**TOWN OF MOUNTAIN VILLAGE
REGULAR DESIGN REVIEW BOARD MEETING
THURSDAY AUGUST 1, 2019 10:00 AM
2nd FLOOR CONFERENCE ROOM, MOUNTAIN VILLAGE TOWN HALL
455 MOUNTAIN VILLAGE BLVD, MOUNTAIN VILLAGE, COLORADO
REVISED AGENDA**

3.	10:05	45	Miller	Public Hearing Quasi-Judicial	Consideration of a Design Review: Initial Architecture and Site Review Application for a new single-family residence on Lot 640BR 1, Timberview (continued from July 11, 2019)

4.	10:50	45	Miller	Public Hearing Quasi-Judicial	Consideration of a Design Review: Initial Architecture and Site Review Application for a new single-family residence on Lot 640BR-4, Timberview

SITE PLAN/ROOF PLAN
SCALE: 1" = 5'

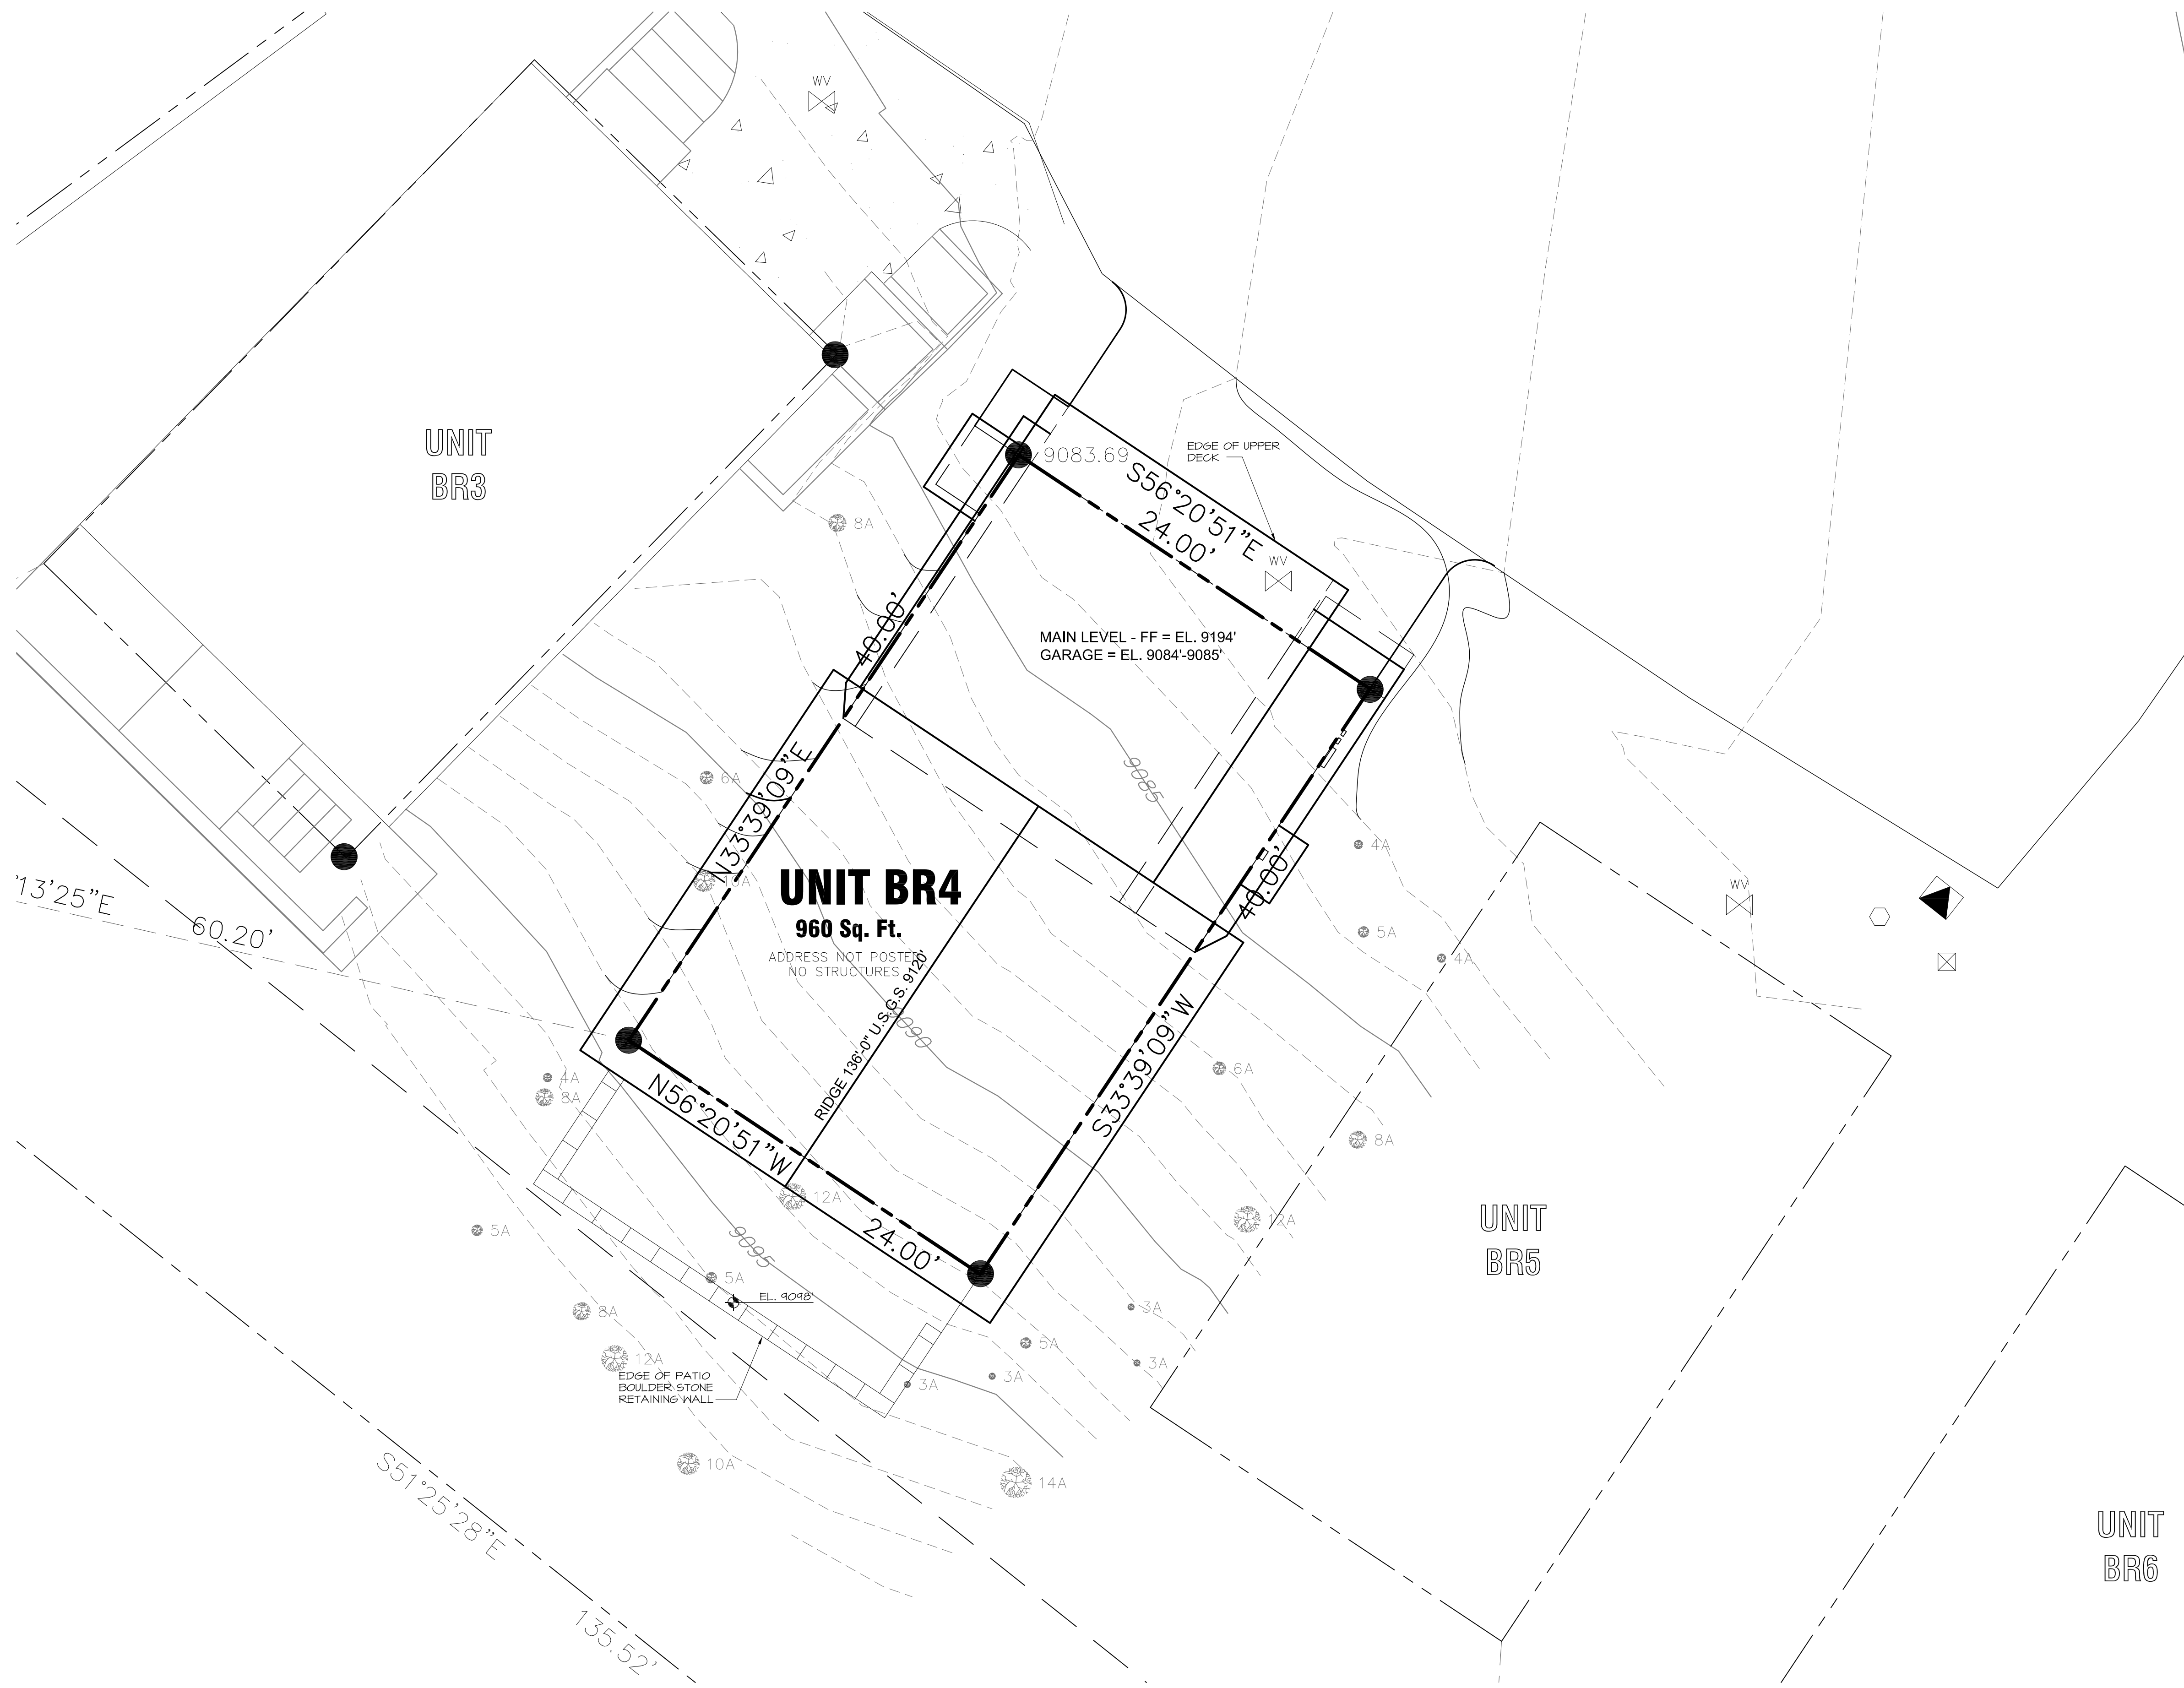
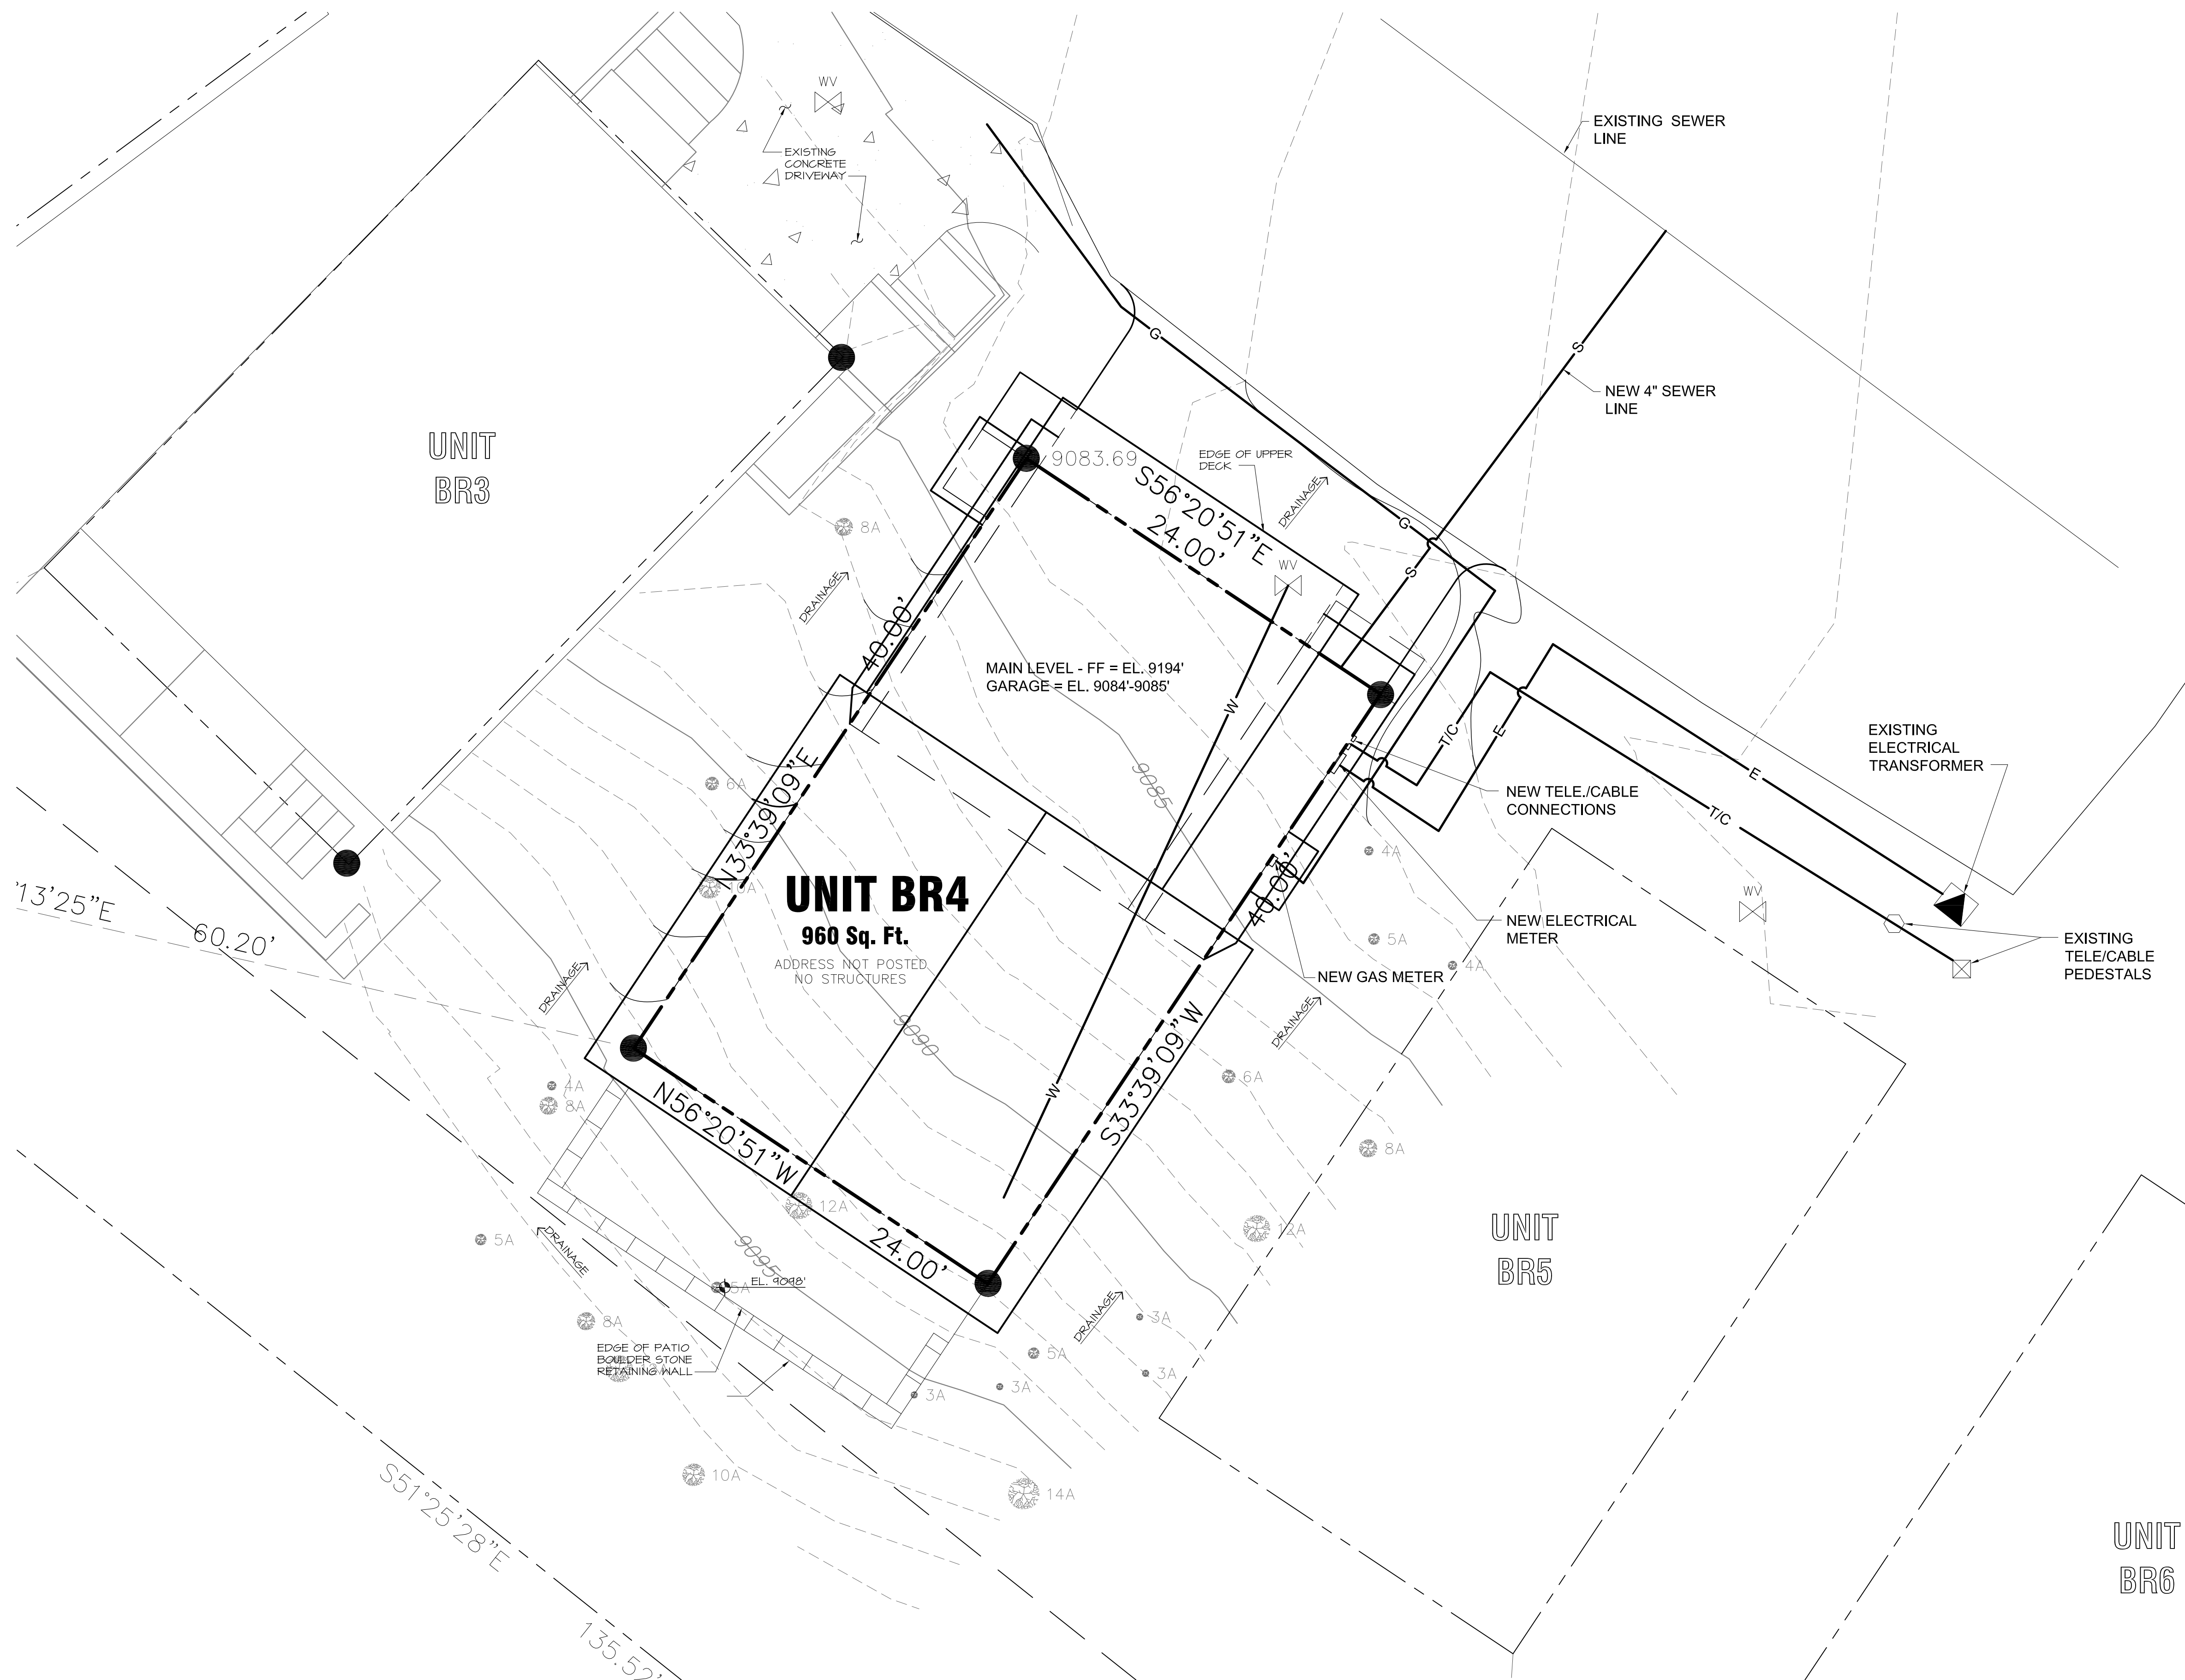
The CDC provides that the GE and other setbacks be maintained in a natural, undisturbed state to provide buffering to surrounding land uses. The CDC does provide for some development activity within the GE and setbacks such as Ski Access, Utilities, Address Monuments, and Fire Mitigation. All encroachments not listed above will require encroachment agreements between the property owner and the Town.

Staff: As previously mentioned, the driveway for Timberview has been developed prior to this project and will not be modified. Within the project area of Lot 640BR-4, there is a proposed driveway area and staff is requesting additional materials related to width and surfacing.
